areas of probable surface disturbance related to the AUMs. JSGS DOQQs with a transparent topo map overlay are reclamation projects. The light blue outlined areas are portrayed for the Upper Waterfall Spring Canyon area. The red boxes are AUMs based on Navajo AML

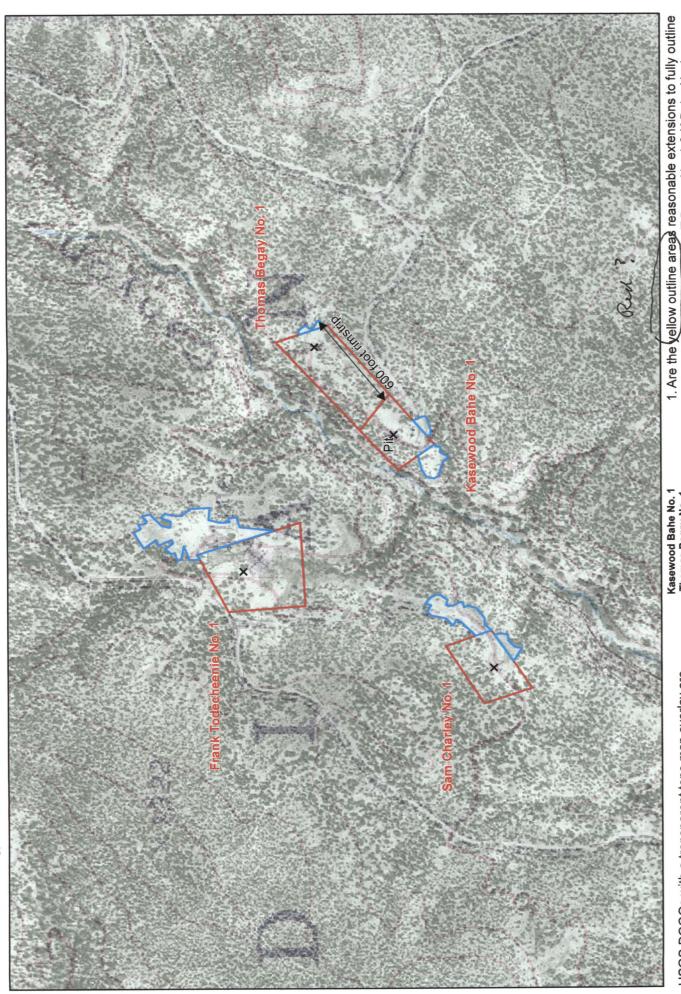
Looks OK. See claim map. Sorry I don't have a letter copy so you can read all notes that were penciled in.

O's <u>may</u> refer to stockpiled ore. Check the certification info I sent you earlier, to see what it says.

each AUM? 2. We know that T Begay No. 1 & K Bahe No.1 are contiguous. Is the Thomas Begay No. 1 the northern of the two? 3. Is the split between the T Begay No. 1 & K Bahe No.1 mines reasonable? It is based on Scarborough description of the T Begay No. 1 being a 600ft rim strip.
